Williamson is part of the Third Lake Ridge Historic District. The 800 south block, the proposed project site, is an intact historic block (other than the applicant's 803 building, built in 2018, and 817). The Landmarks Commission determines whether new construction meets the adopted standards and guidelines for a particular historic district as set forth in Chapter 41. The Third Lake Ridge's standards and guidelines were created in 1979 and remain unchanged.

### Proposed 817 project

## CONDITIONAL USE:

**A mixed-use or multi-tenant building exceeding 25,000 sq. ft. in floor area**

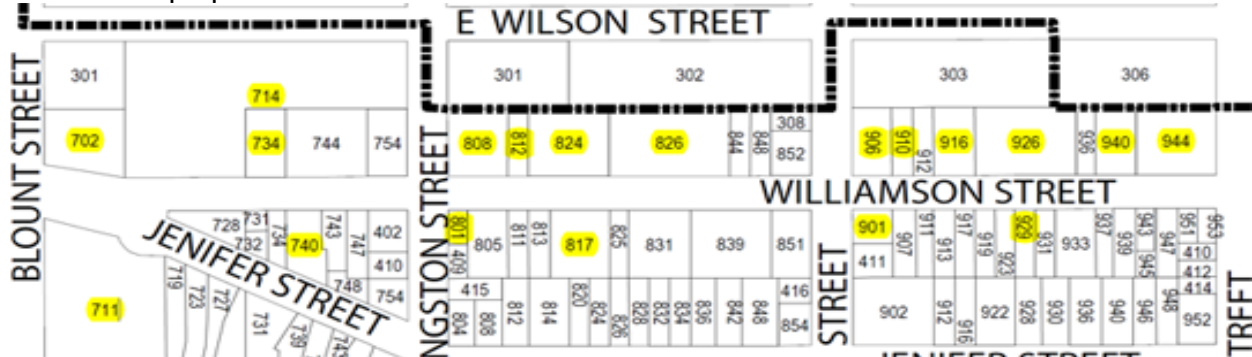
4. Accessory buildings. The Preservation Planner believed that the back garage portion, set back from Williamson (then by 59'8", now 57') reads as a separate building: "The entrance to the garage in the back can read like a separate garage in the back of the lot, which is a feature of other historic resources in the vicinity."  
<https://madison.legistar.com/View.ashx?M=F&ID=8567155&GUID=D1079A21-6F8A-4F8F-ABAF-0B8BE5B0B099>

There is only one building. But, if for some reason this can be deemed two portions to this integrated building, BUILD II provides that accessory buildings cannot "exceed fifteen (15) feet in height and shall be as unobtrusive as possible." This "accessory building" is about 38' in height at its entry point.
